To: T10 Committee (SCSI)

From: George Penokie (LSI)

Subject: SAS-2: Making 07-267 into an Annex

This is the re-creation of 07-267r1 putting it into a form that can be placed into the SAS-2 standard as an informative annex.

**Figure A.1 — S-parameters modeling circuits for simulation**

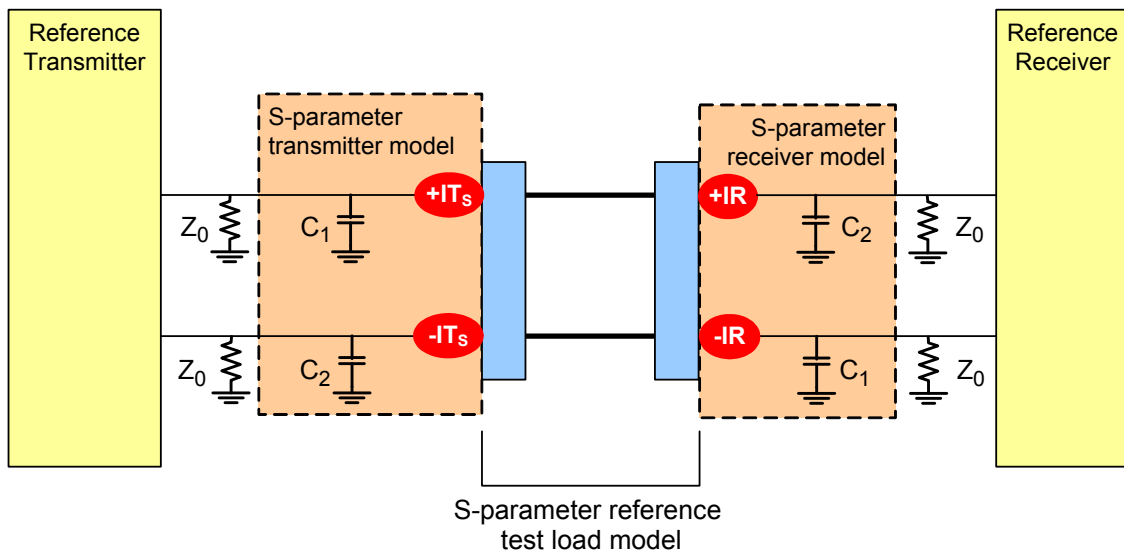
**A.2 Simulated S-parameter model**

**A.2.5 Simulated S-parameter model overview**

The S-parameters are able to be simulated using simple circuits to represent:

- a) a reference transmitter (see figure A.1);
- b) a reference receiver (see figure A.1); and
- c) the return loss (see figure A.4).
